FINAL PLAT

ELIZABETH'S ADDITION

Re: S/D 91-12 (Final Plat) Elizabeth's Addition

01-12 - ELIZABETH'S ADDITION

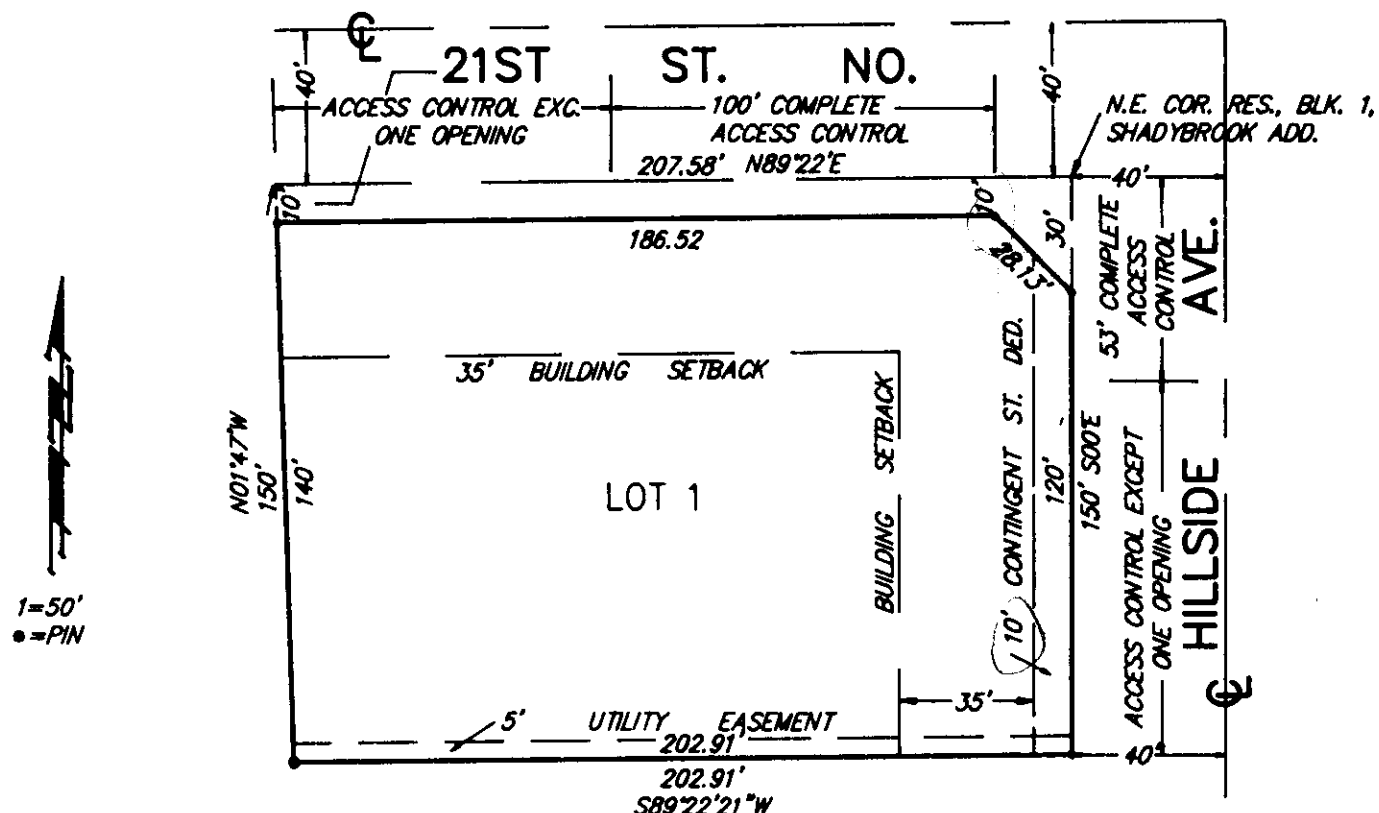
building setbacks do not preclude the property owner from maintaining or remodeling that portion of the building within the setback area. The building cannot, however, be enlarged within the setback and, if the building is removed, any new building construction must observe the platted building setback.

- J. Presently, one of the owners of this site is indicated as J. and Viola Chenn. The final plat tracing shall either include these owner's signatures or a revised title policy will need to be submitted indicating the change in ownership, as now shown on the plat (Julius and Lois Smith).

- A. The applicant shall guarantee the closure of those driveways in excess of the access controls being established for this plat. Specifically, the closure of two drives to 21st Street North, and one drive to Hillside.

- B. The applicant shall submit a guarantee for the provision of a decel lane to serve this site. This guarantee will be held pending determination of whether landscaping improvements along 21st St. North would make such an improvement inappropriate.

- E. Subdivision Regulations state that the right-of-way for intersections of major arterials shall be 75-feet of half for a distance of 250 feet from the intersection, tapering to 50-feet of half. Since this is a developed area, 60-feet of half street right-of-way will be required along both 21st St. North and Hillside as indicated by the original Quiktrip 5th Plat.

- F. Prior to submitting the final plat tracing, the applicant shall also meet with Traffic and City Engineering to determine the amount of right-of-way to provide at the plats northeast corner for the 21st and Hillside intersection.

- G. The access control, as shown, may be inadequate for the amount of right-of-way required. The final plat tracing shall indicate 40-feet of complete access control allowing for the additional right-of-way along Hillside from the intersection of the arterial streets.

- H. On the final plat tracing, a 10-foot utility easement shall be indicated along the site's south line. Utilities and sanitary sewer are located in what is presently only a 15-foot easement, 5-feet being on this site and 10-feet on the adjoining property. A 20-foot easement is required.

- I. The final plat shall indicate the platting of the 35-foot building setback from 21st Street North and Hillside through the existing buildings which encroach into the setback areas. Central Inspection has advised that the platting of these
